re: **Grading and Site Servicing Plans Review**
Proposed Warehouse Building
6165 Thunder Road, Ottawa, Ontario

file: PG6430-MEMO.01

Figure 3 - Typical Frost Insulation Detail

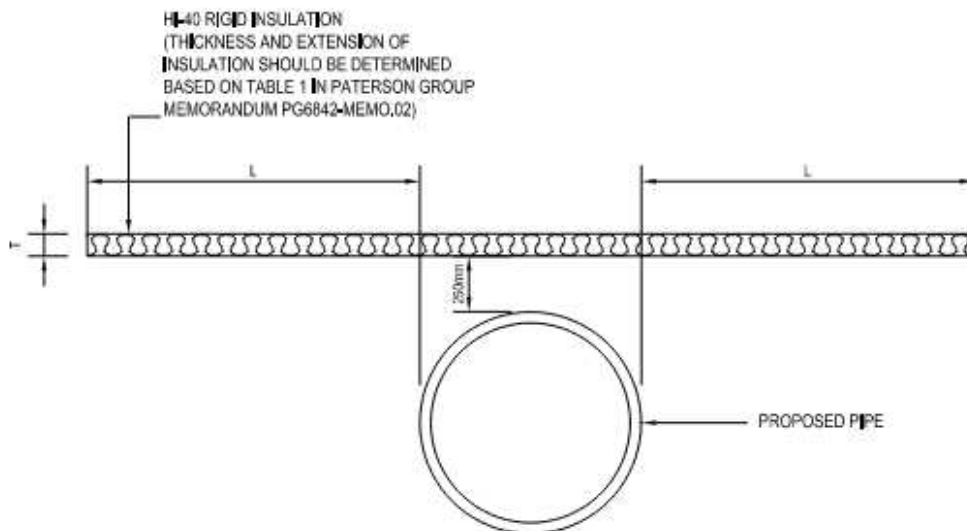
Further, it should be noted that all watermain pipes have been provided with sufficient soil cover at the subject site for the frost protection. However, insufficient frost protection has been provided for the majority of the proposed storm pipes throughout the subject site. The proposed storm pipes are located within the frost zone, which is the zone located within the upper 2.1 m below the finished grade. It is understood that the proposed storm pipes will be insulated. It is recommended that Paterson review the insulation detail to provide an input from a geotechnical perspective.

Any portion of the services installed at a depth of 2.1 m below finished grade or deeper is considered to have sufficient soil cover for frost protection. Where insufficient soil cover is present above the invert of storm and sanitary sewer pipes, the following frost protection criteria should be followed:

All rigid insulation should consist of either Dow Chemical High-Load 40 (HI-40), Styro Rail SR.P400, or equivalent approved by Paterson. The placement of all insulation within the service trenches must be reviewed and approved by Paterson personnel at the time of construction. Reference should be made to Figure 3 - Typical Frost Insulation Detail below:

The above detail can be used if the storm pipe is confirmed to be within the frost zone. Insulating the pipe alone without the soil may cause differential settlement in the future, therefore, the above detail provides a sufficient insulation to the pipe and the subgrade below the pipe.

FIGURE 1

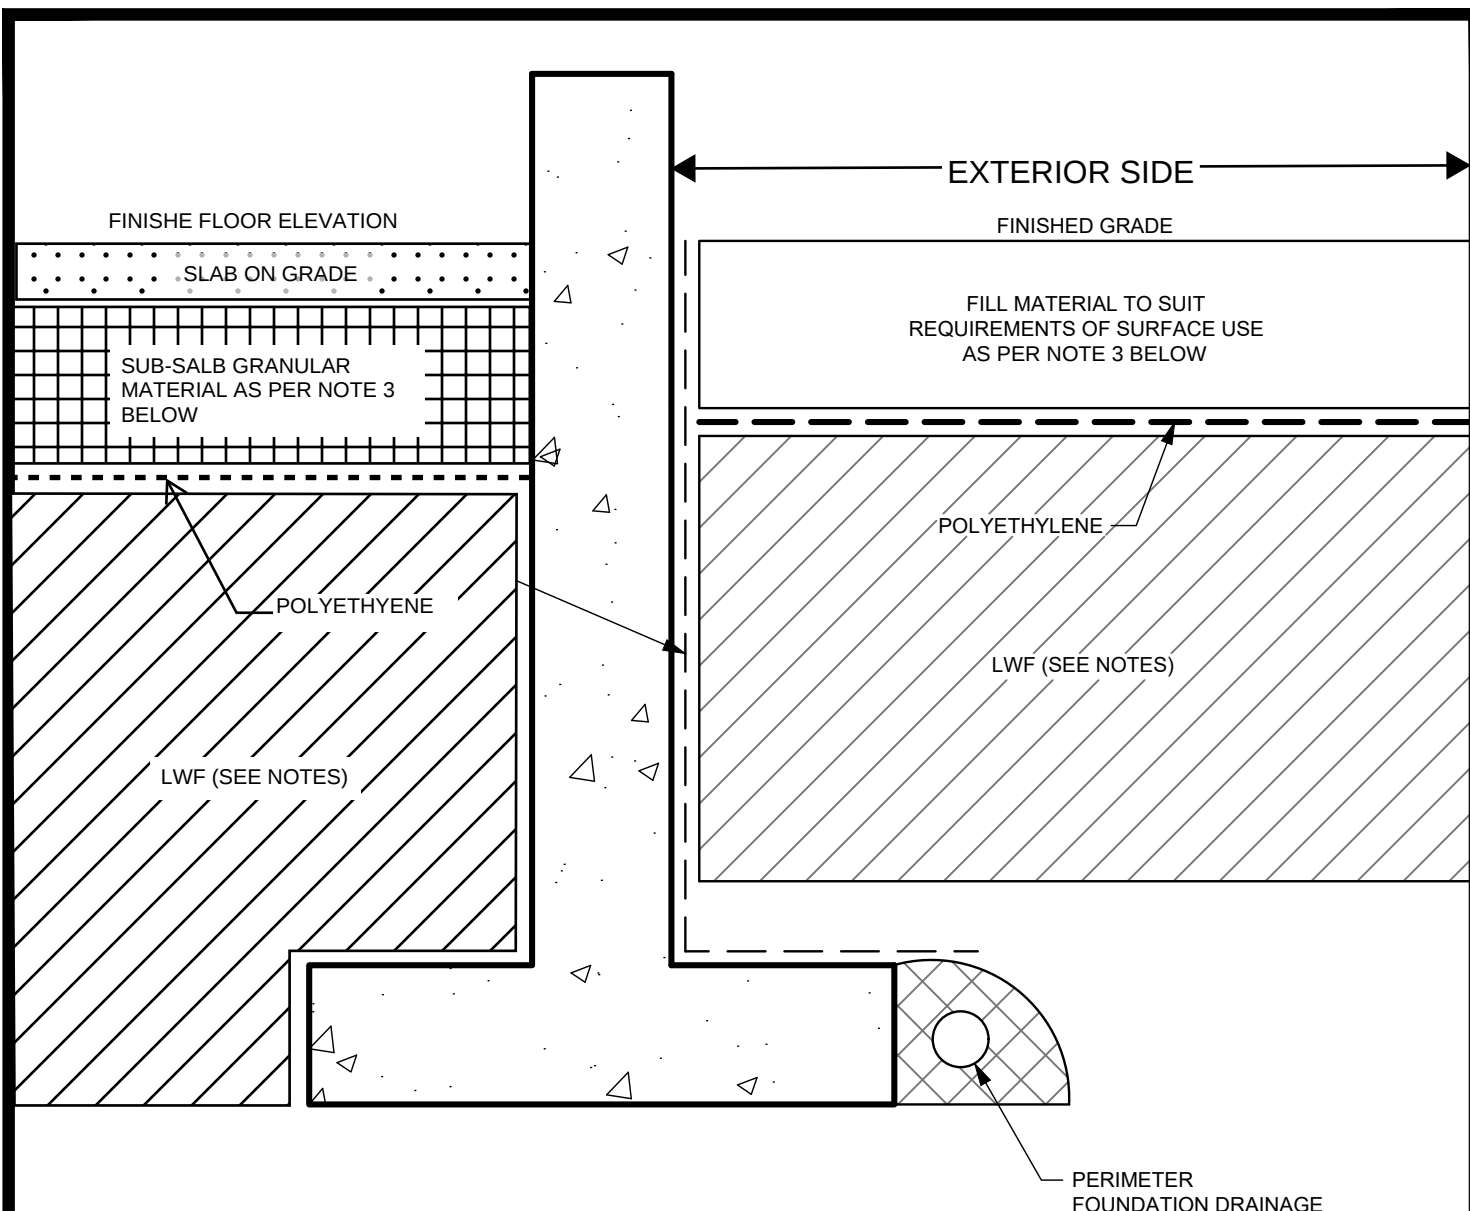
Based on our review of the above-noted drawing, the proposed building grading was found to be exceeding the permissible grade restriction assigned for the subject site within the footprint of the proposed building. The exceedances were found to range from 0.35 to 0.65 m above the permissible grade raise restriction. Therefore, LWF recommendations have been assigned to reduce the impacts of the load exerted from the additional soil needed to raise the grade to the proposed grades. It is important to note that the LWF will be recommended to be placed below the slab on grade as well as the perimeter of the proposed building extending horizontally a minimum 6 m beyond the foundation walls. Reference should be made to the attached Figure 1 – EPS Block Installation and Figure 2 - Lightweight fill Recommendations, attached to the end of this report.

1. USE EPS12 BELOW LANDSCAPED AREAS
2. USE EPS15 BELOW GARAGE DRIVEWAY AND INTERIOR AREA
3. MINIMUM GRANULAR THICKNESS OVER LWF SHOULD BE AS FOLLOWS:

FRONT PORCH	150mm OF OPSS GRANULAR A
GARAGE	300mm OF OPSS GRANULAR A
DRIVEWAY	450mm OF OPSS GRANULAR A
LANDSCAPED	500mm OF APPROVED BACKFILL SOIL
INTERIOR AREA	300mm OF OPSS GRANULAR A
4. PLACEMENT OF LWF SHOULD BE ON A LEVELED SURFACE (SAND CAN BE USED TO PROVIDE AN ADEQUATE LEVELLING SURFACE).
